AGENDA
CANBY PLANNING COMMISSION
REGULAR MEETING
City Council Chambers
October 22, 1990 - 7:30 p.m.

- S T A F F R E P O R T -

SUB 90-02

- S T A F F R E P O R T -

EXHIBIT
2
528 70

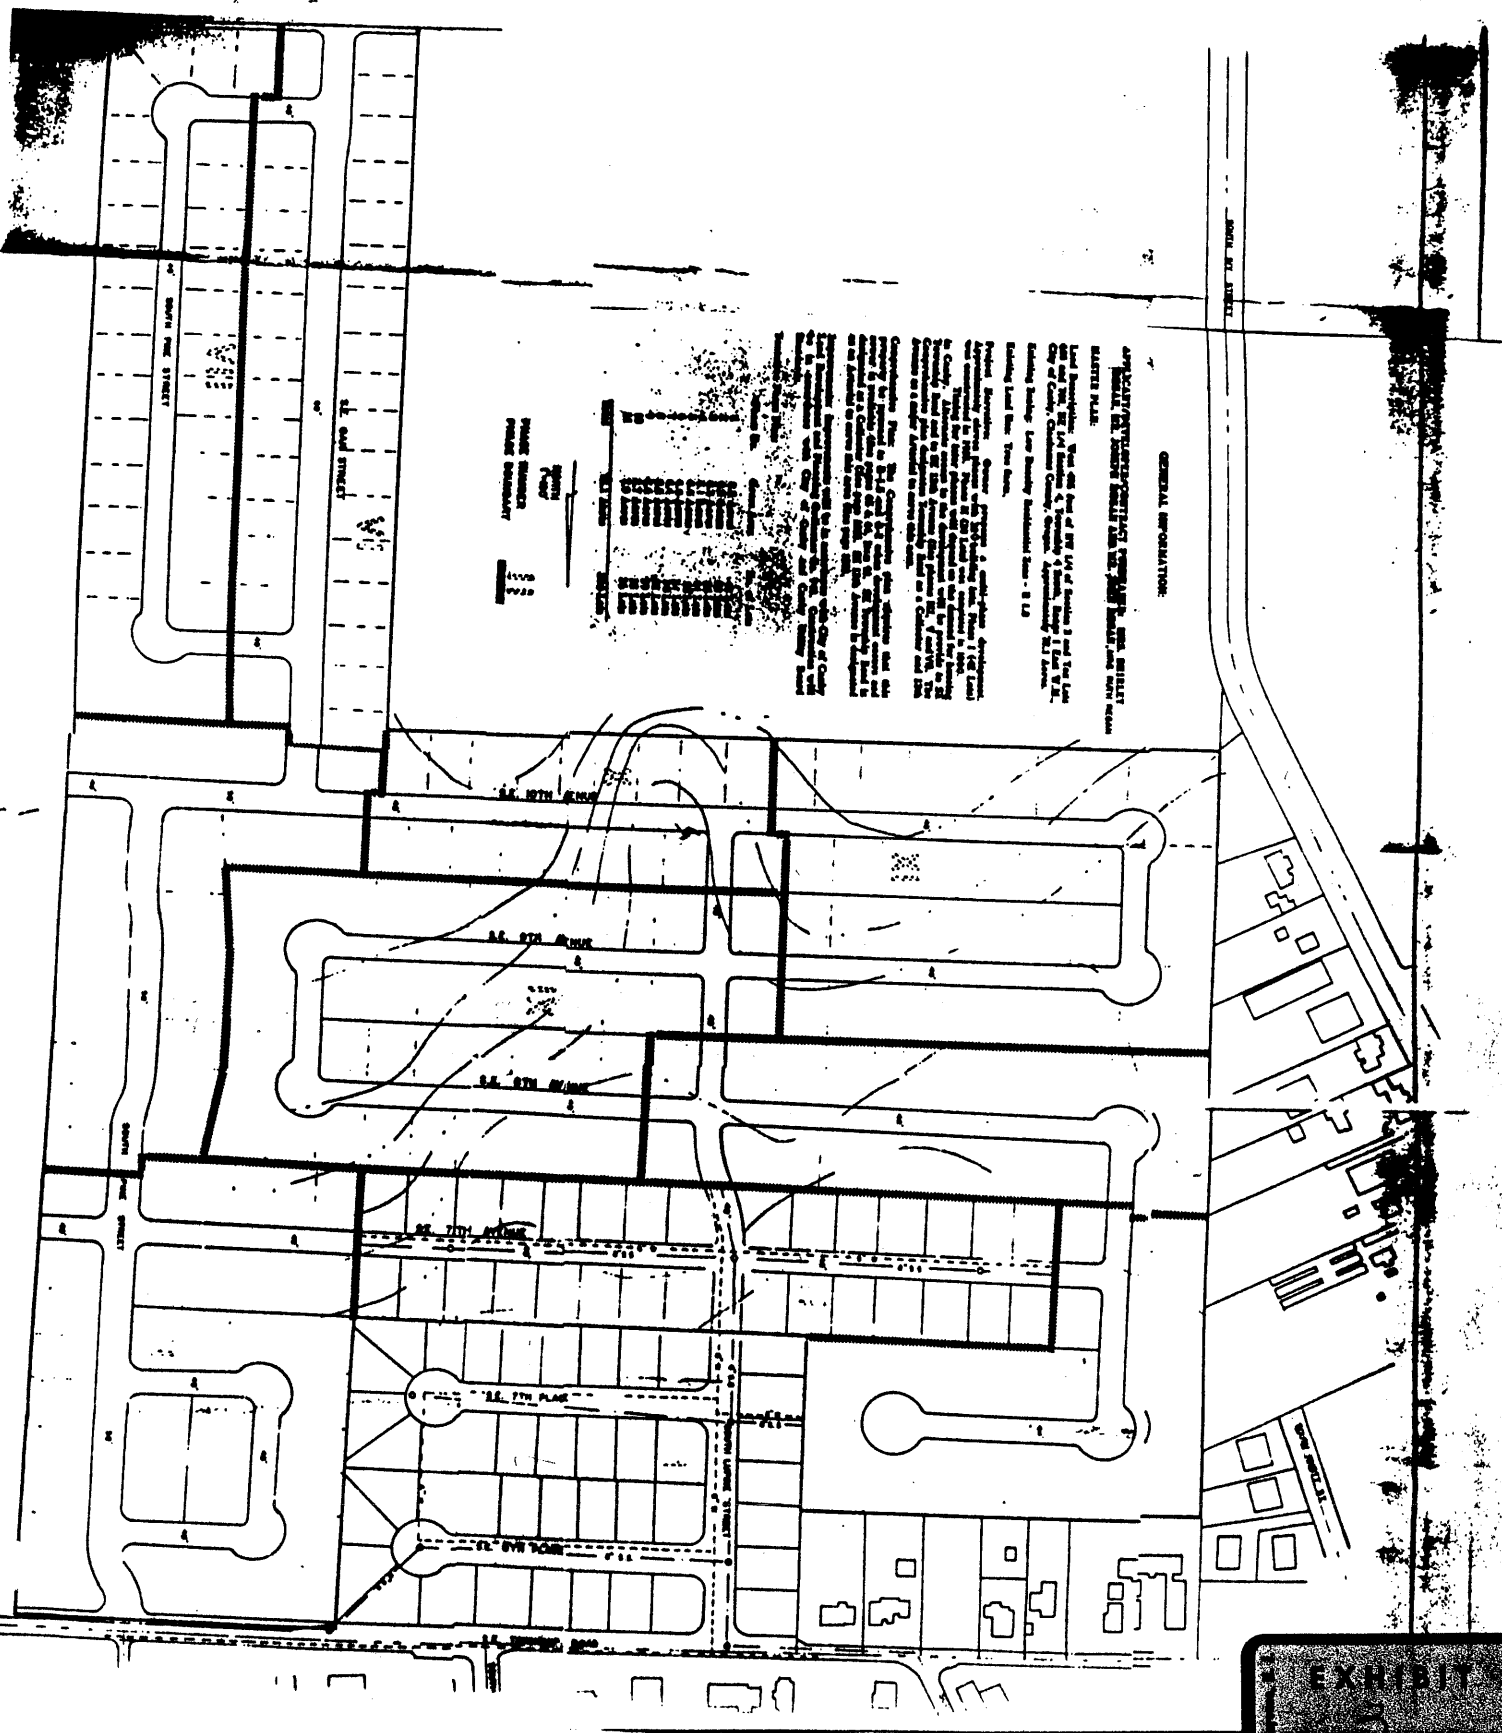
east. Currently, Knott Street dead-ends on the northwestern corner of the site. No provision for extension is made in the proposed Master Plan. It should be indicted to connect to the loop at the end of 7th Avenue. Children's pedestrian needs, for safe school access, must be provided.

1. The proposed Master Plan shall be modified to provide a connection of Knott Street to the loop road northwest of the western end of 7th Avenue. Also, a pedestrian connection to Philander Lee Elementary School shall be provided from Township Village. Such modifications shall be reviewed and approved by the Planning Director.

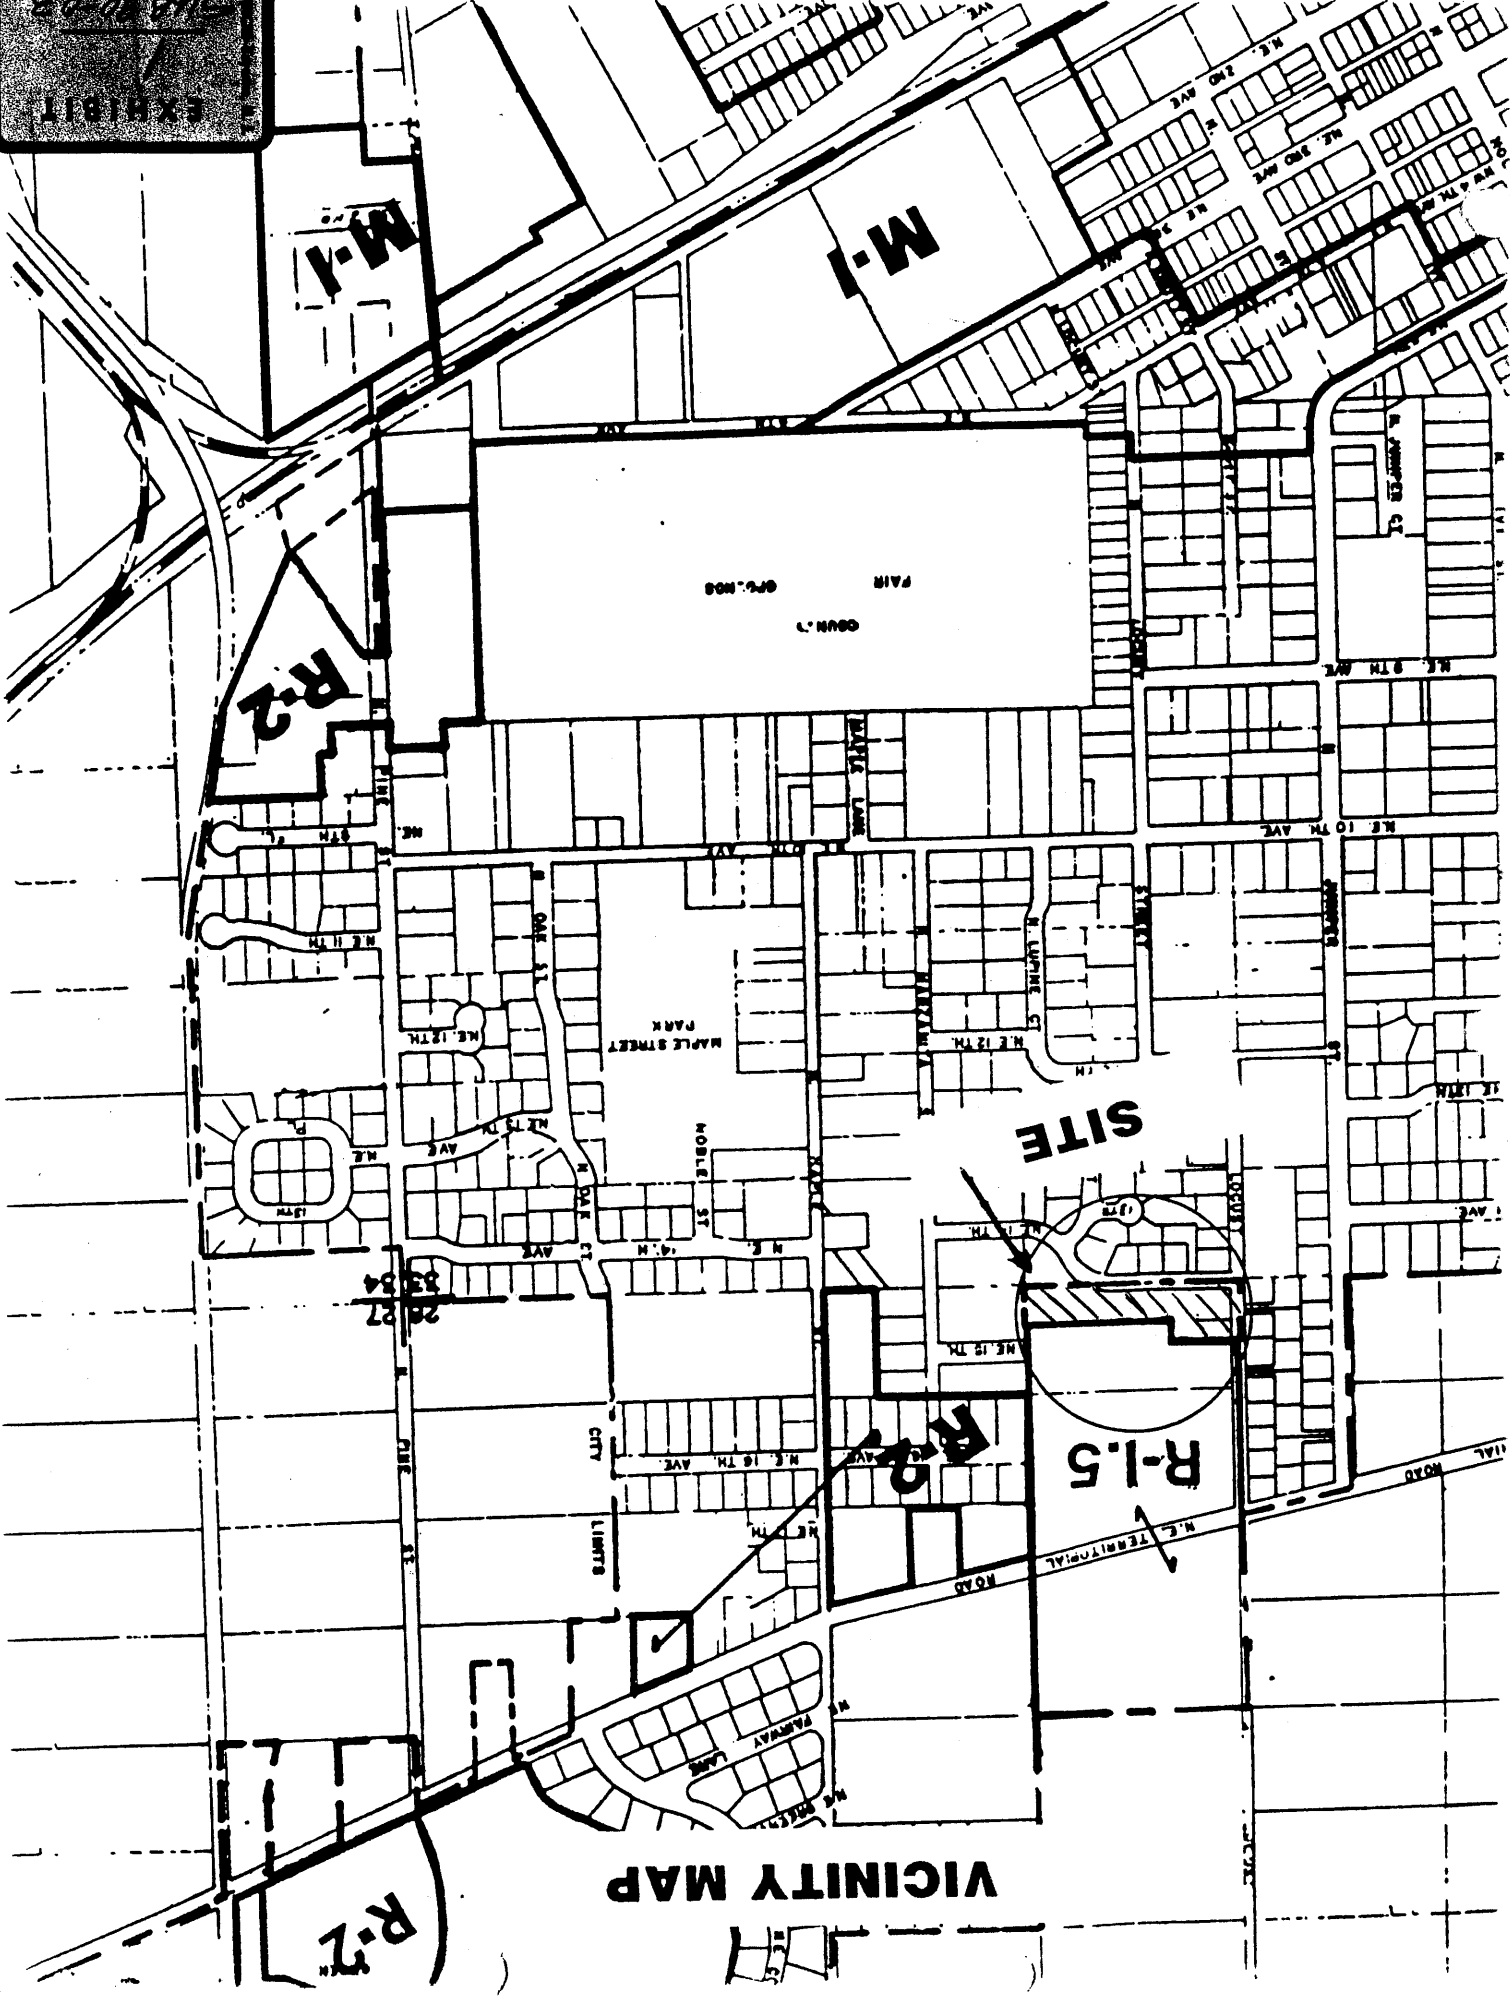
Lot 1 should be eliminated and the plat returned to the earlier plan (9 lots) for developing this parcel.

The proposed plan shows two lots (Lot 1 and Lot 2) with an east/west orientation. The other lots all have the preferred north/south orientation. By eliminating Lot 1, all lots in the subdivision will have the preferred north/south orientation.

**CITY OF CANBY
CEDAR CREEK COMMUNITY
TENTATIVE SUBDIVISION PLAN**

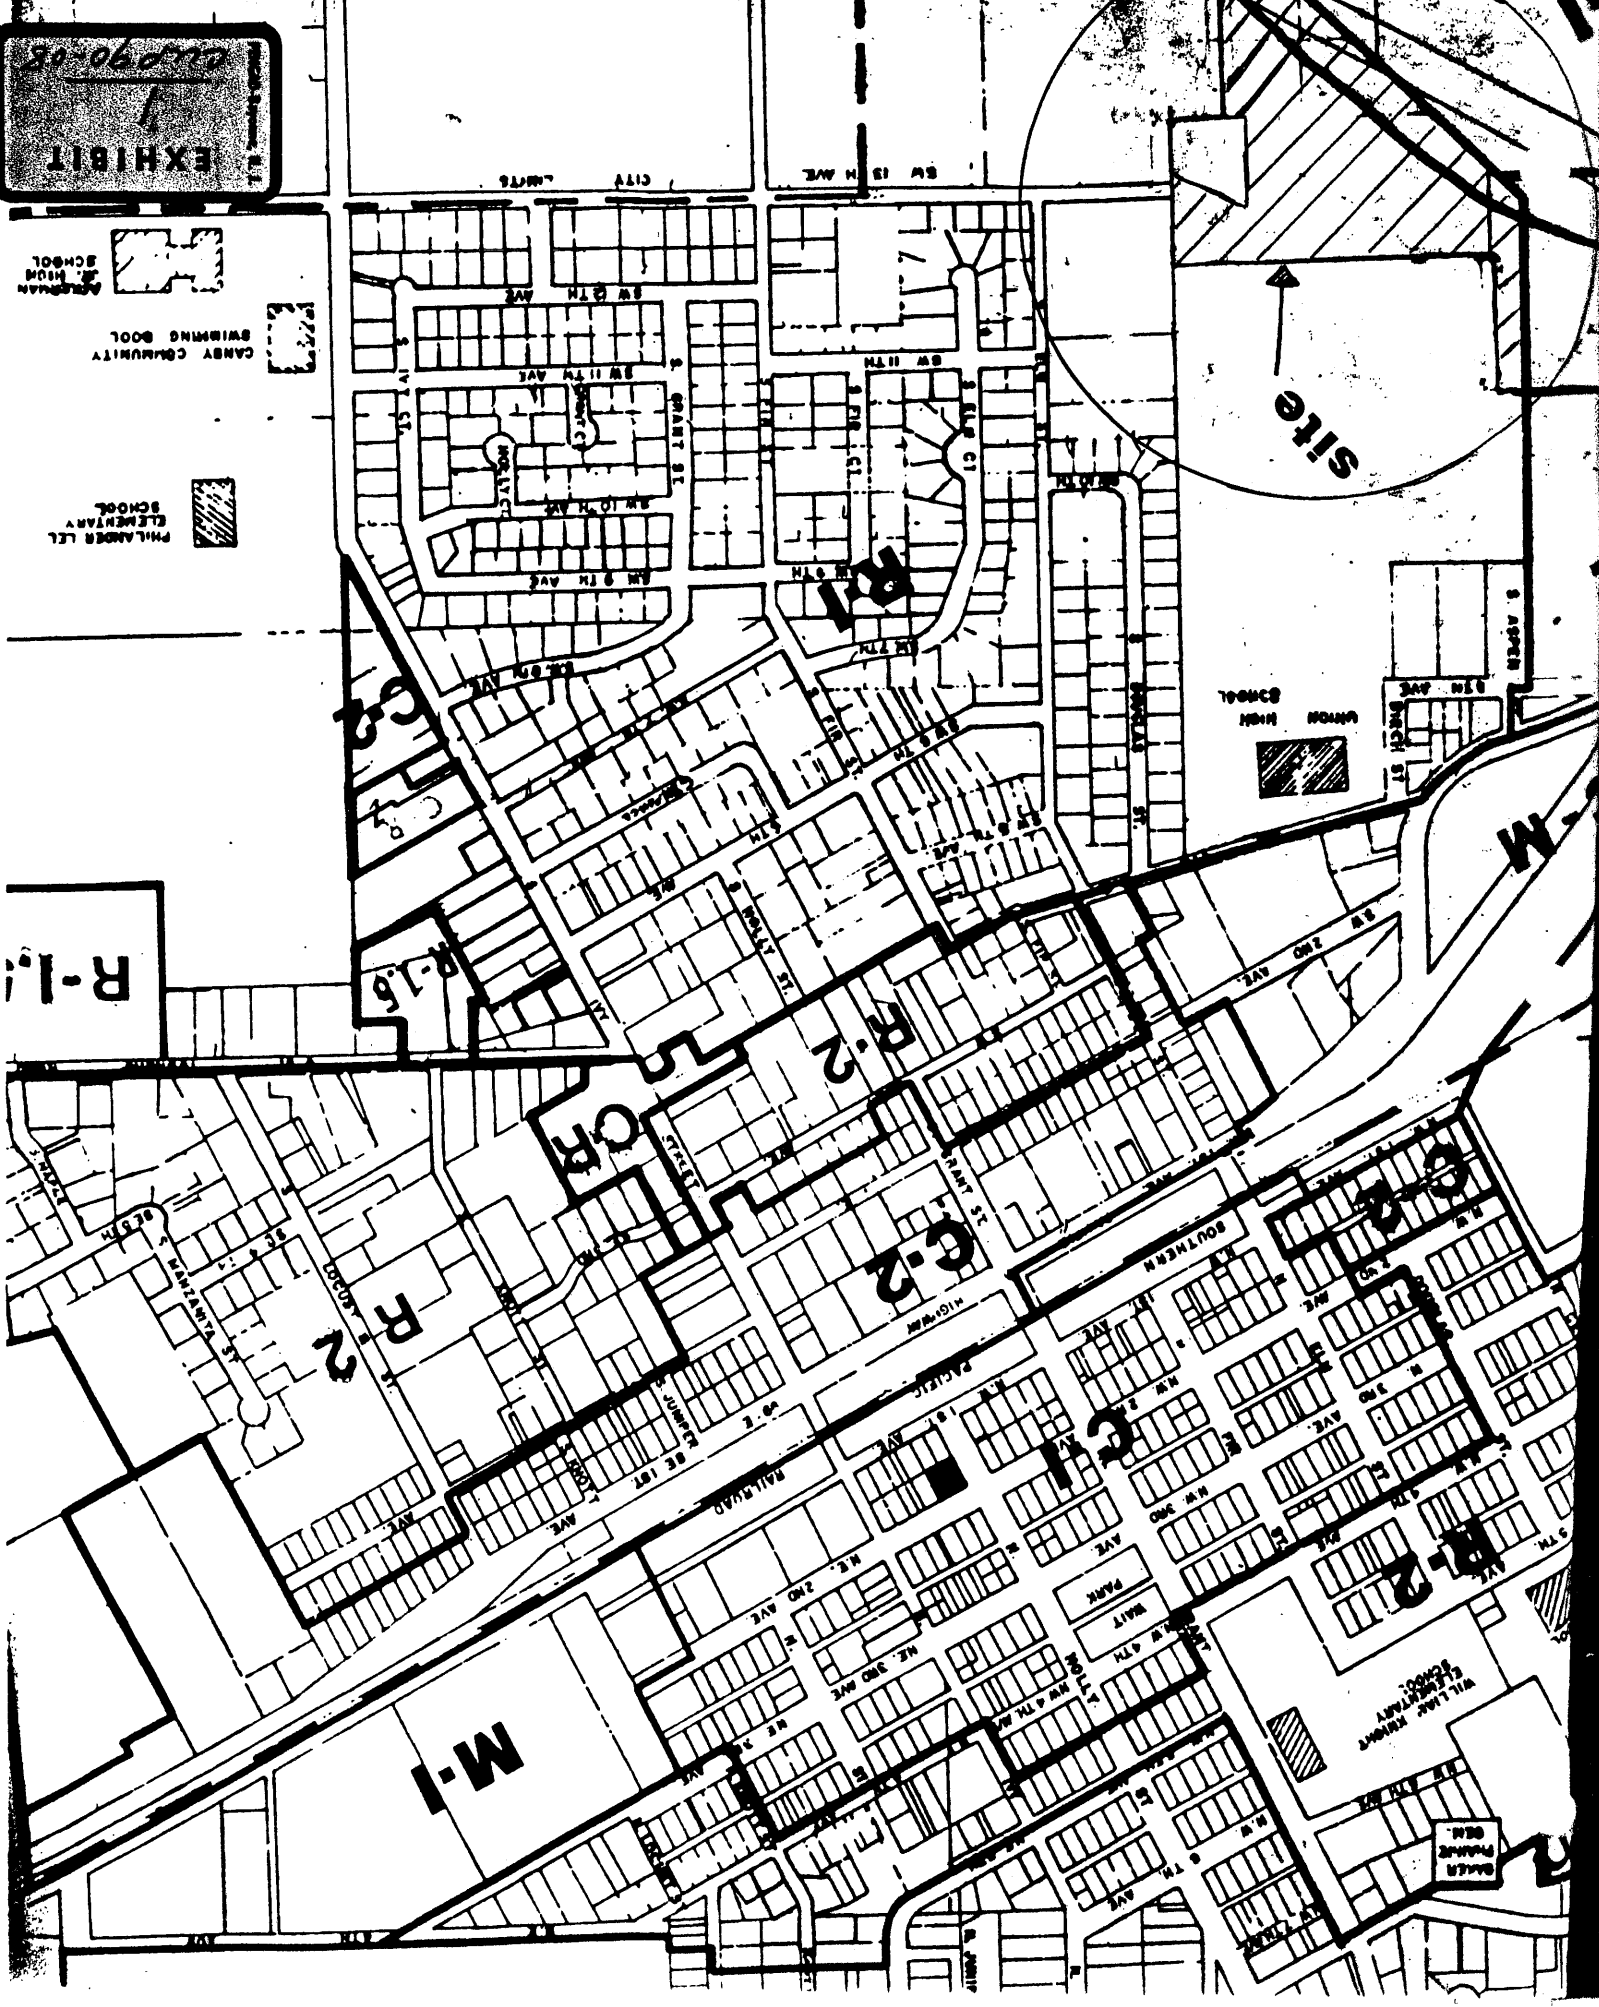
- With regard to #9 - no three-story units are proposed as part of this development.
- With regard to #10 - "the northeast corner is to remain as open space". Staff finds that the redesign of 13th Avenue extension to a smoother curve with longer radii results in a substantially larger area in the northeast corner of the parcel than under the previous plan. The proposal, under the present plan, is to develop this area with a small "court" off 13th Avenue. The court will house 8 attached single family units on separate lots, as small landscaped areas. This new proposal is a reasonable solution to the situation created by the street extension. Staff concludes that limiting the area to "remain as open space" is no longer necessary, since it can be developed in a reasonable fashion which will benefit both the site occupants and surrounding land use.

7. The applicant shall provide the City with a dedication of property, as indicated on the tentative subdivision plat dated September, 1990, to allow for the extension of S.W. 13th Avenue. The dedication shall meet the requirements of the City Attorney and construction costs shall be borne by the applicant.
